SECTION 2:
ADDENDUM AND ERRATA

The following sections have been prepared in response to public and agency review comments on the DEIS. The Addendum Section, Section 2.2, expands upon the air quality analysis found in the DEIS. This expanded cumulative impact analysis is based upon the cumulative impacts from the standpoint of assessing the potential impacts from existing, reasonably foreseeable and proposed sources of emissions. The analysis addresses the construction and operation phases of oil and gas development, the details of which are available in a separate Technical Report entitled *DEIS: Cave Gulch-Bullfrog-Waltman Air Quality Technical Support Document: Cumulative Air Quality Impact Analysis*. The Errata Section, Section 2.3, presents changes to the text of the DEIS organized by DEIS sections. Also, Figures 1-2, 1-3, 2-9, and 3-21 have been modified from the DEIS and are presented at the end of the Errata Section.

2.3 ERRATA

Figure 1-2 Existing Well Sites and Production Facilities within the Cave Gulch-Bulfrog-Walman Project Area

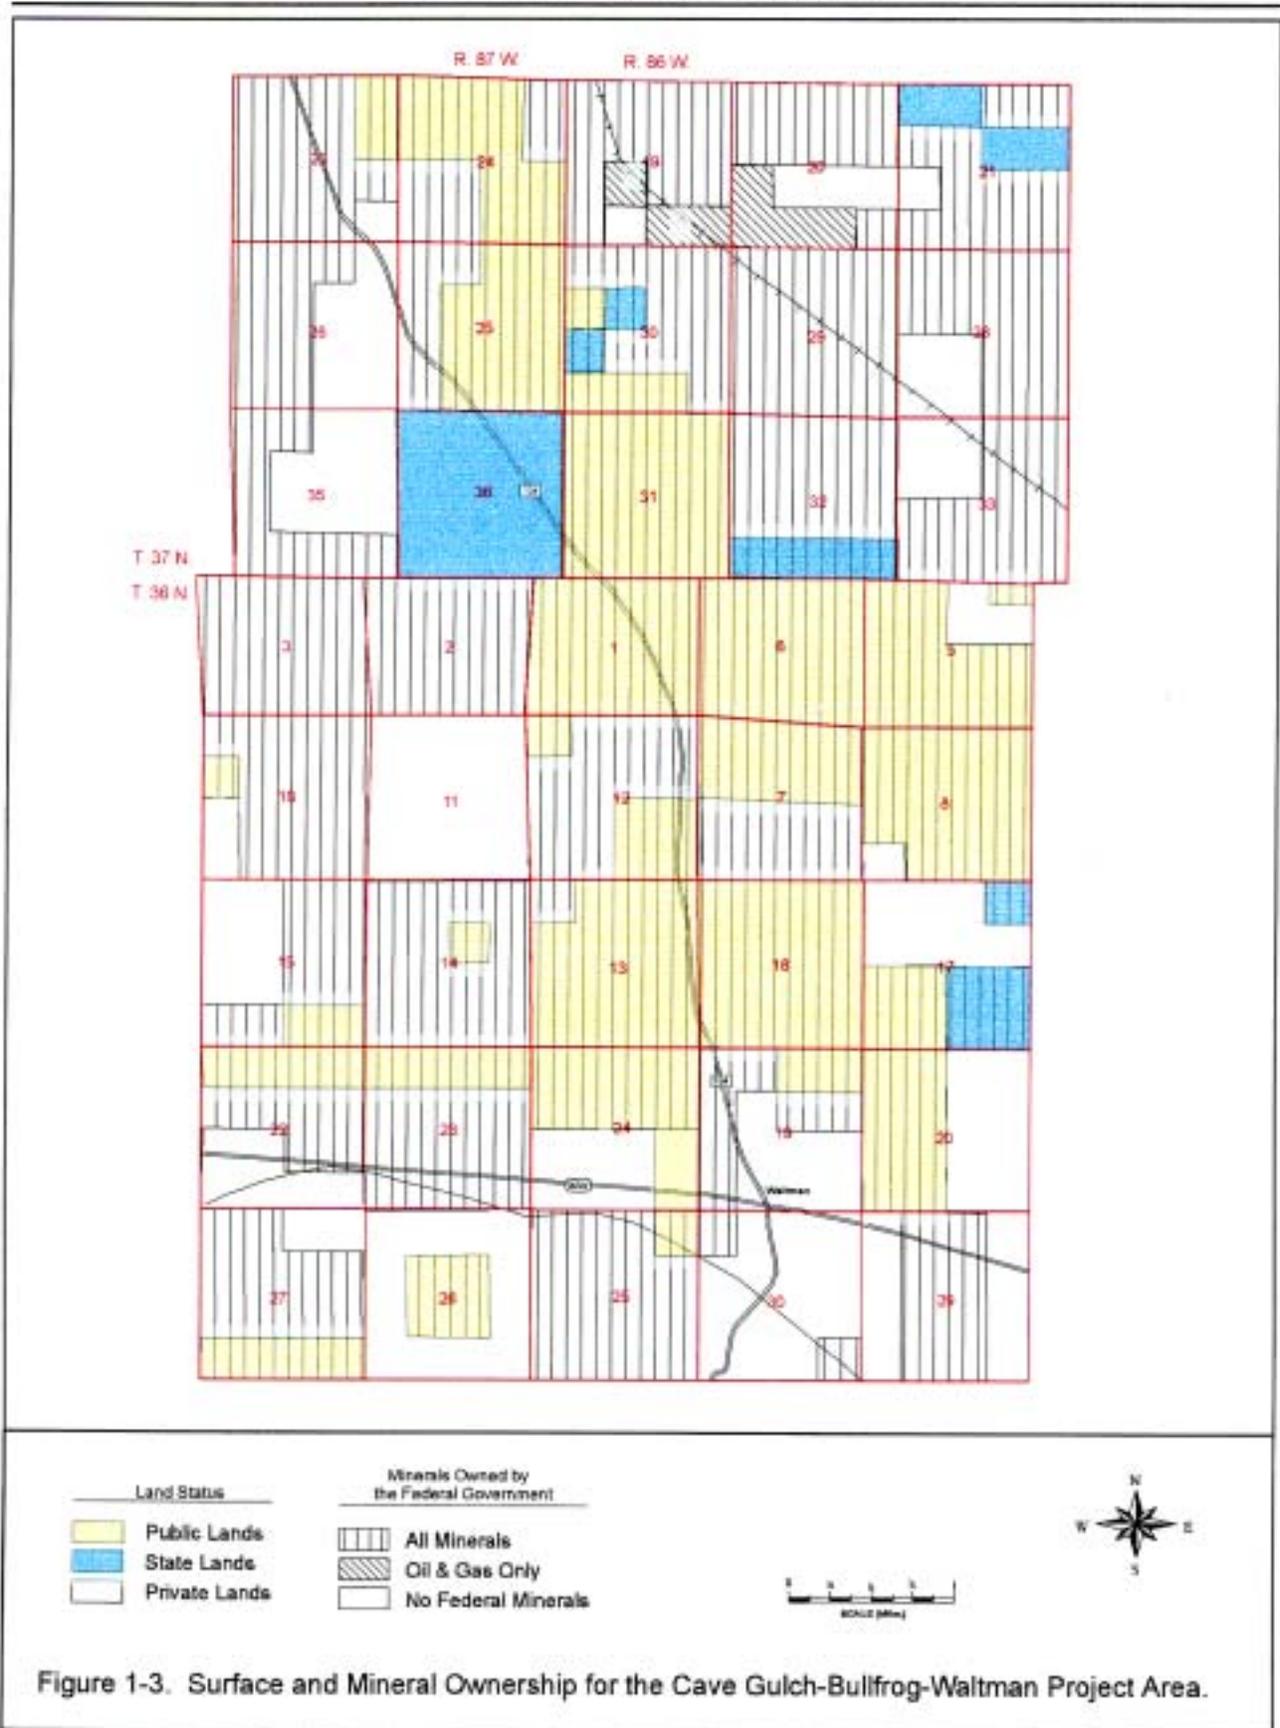
Page 1-1. Add the following to the last sentence of this section: "as shown on Figure 1-2."

Page 2-5. First paragraph, sentence 1 is modified as follows: "...in Figures 1-1 and 1-2."

Figure 2-9. Typical Production Facilities Layout for a Twin Well.

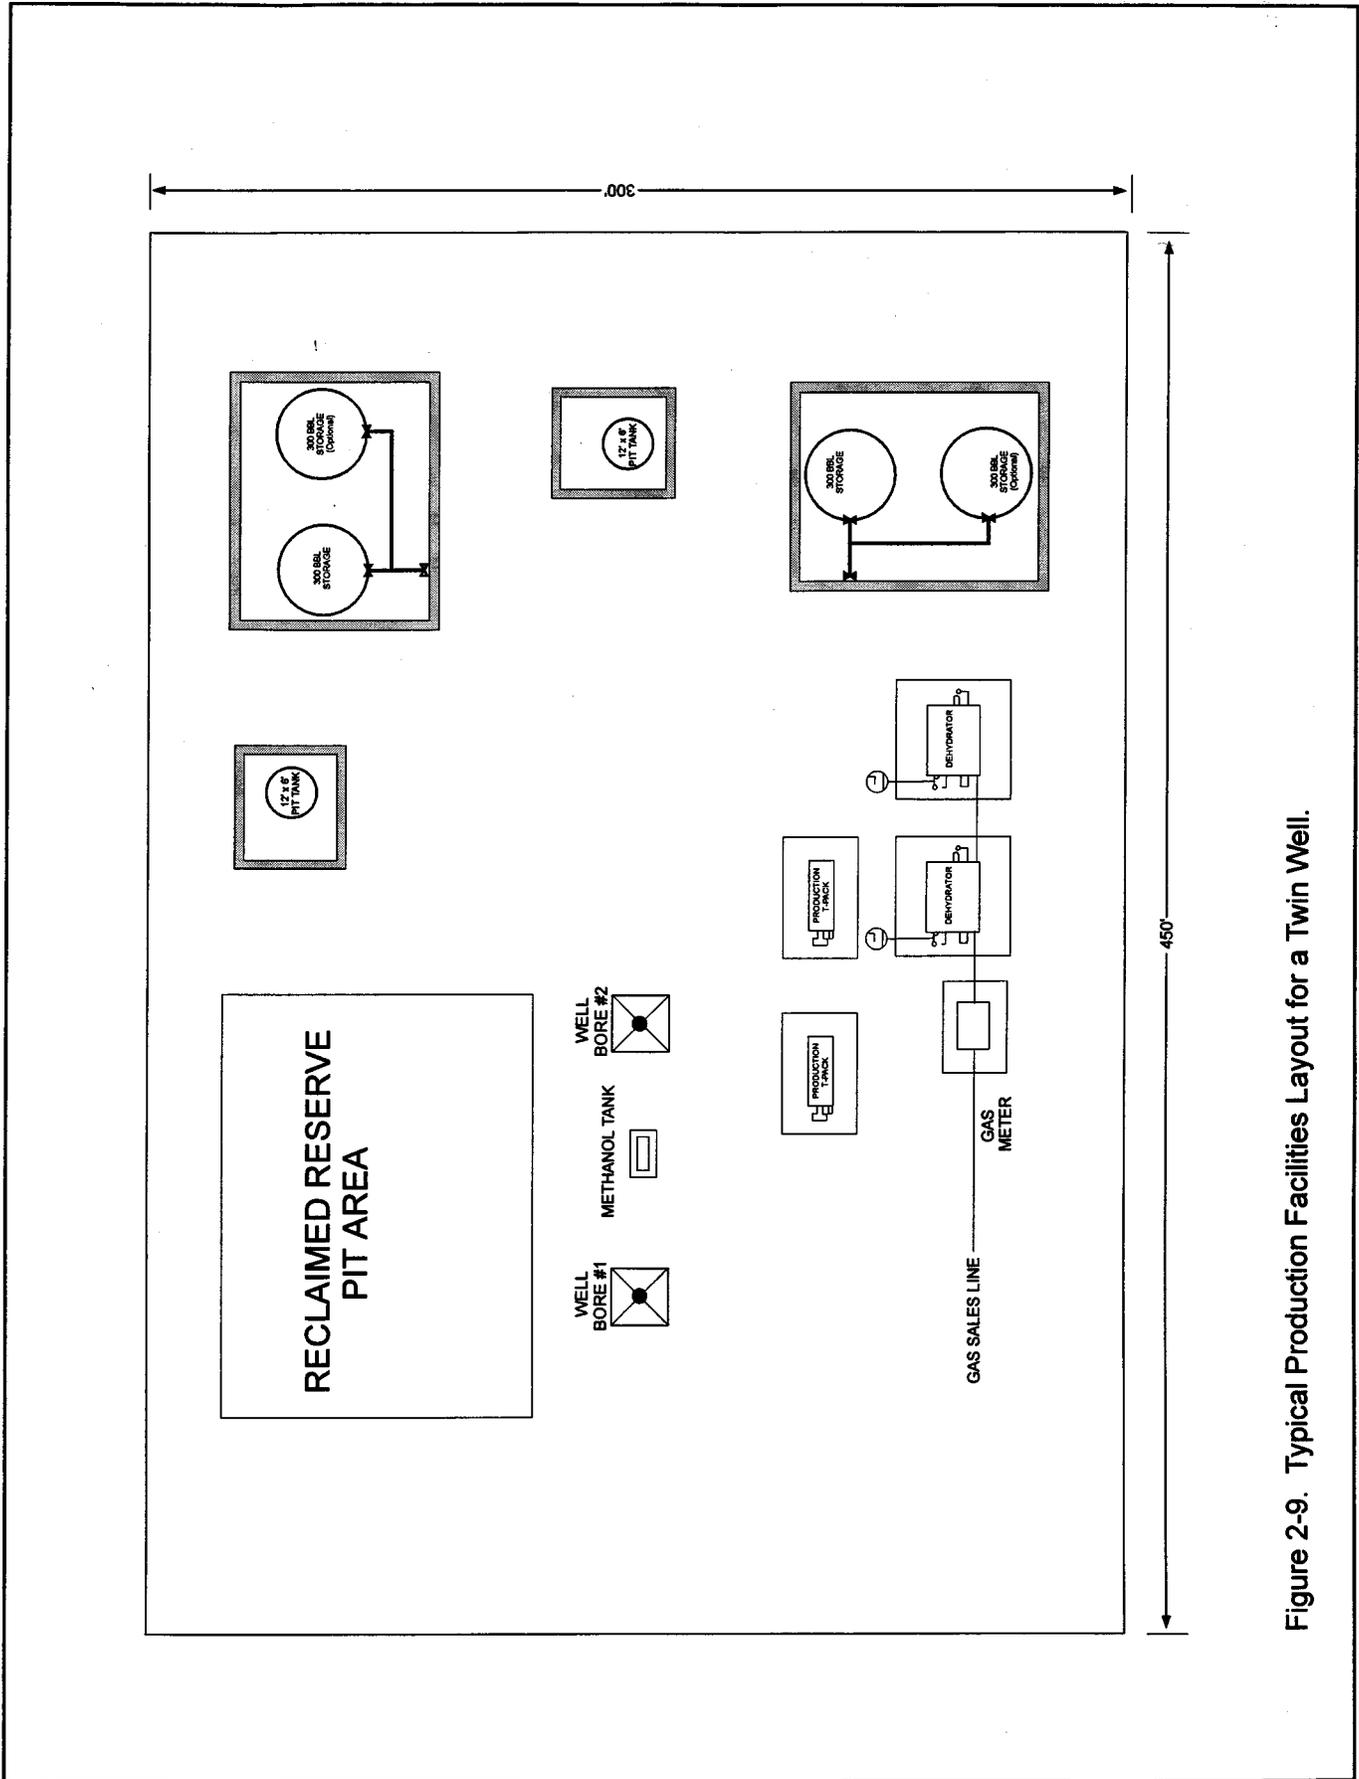
Page 2-25. Figure 2-9 has been modified to include a second dehydrator and a second separator; see corrected figure at end of the Errata section.

Figure 3-21. Transportation Routes within the Cave Gulch-Bullfrog-Waltman Project Area.

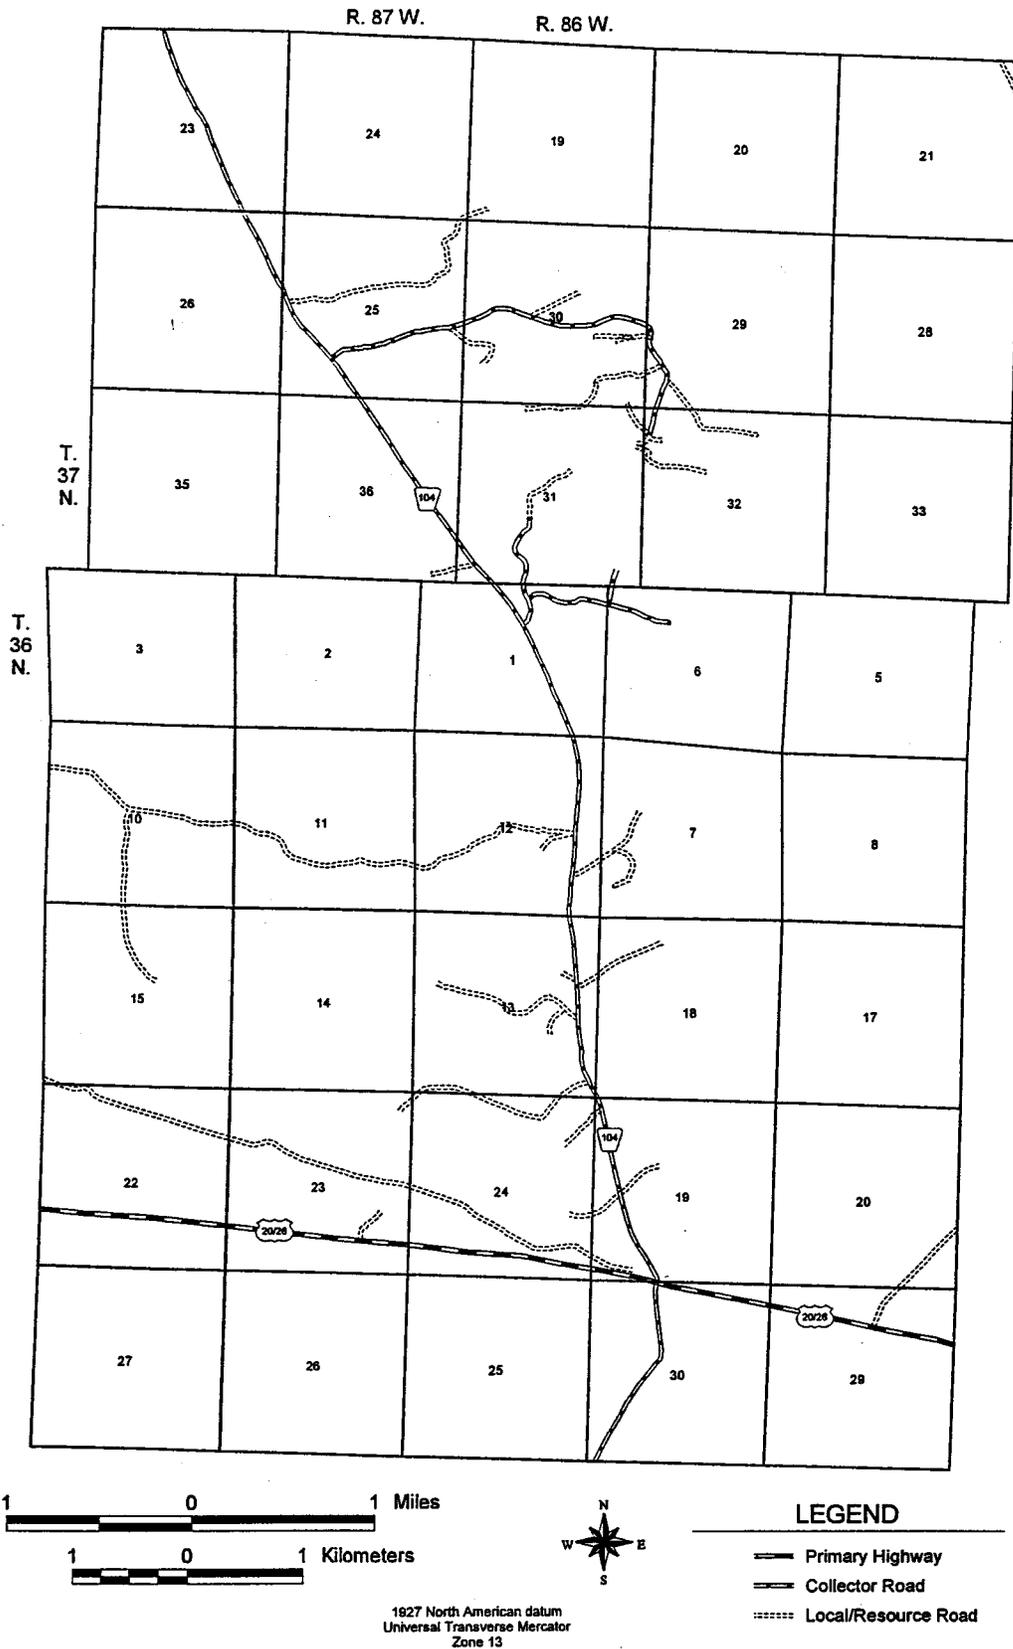
Page 3-94. Figure 3-21. The road classifications shown on the figure have been modified to reflect the correct status of the project area road network. See corrected figure at the end of the Errata section.
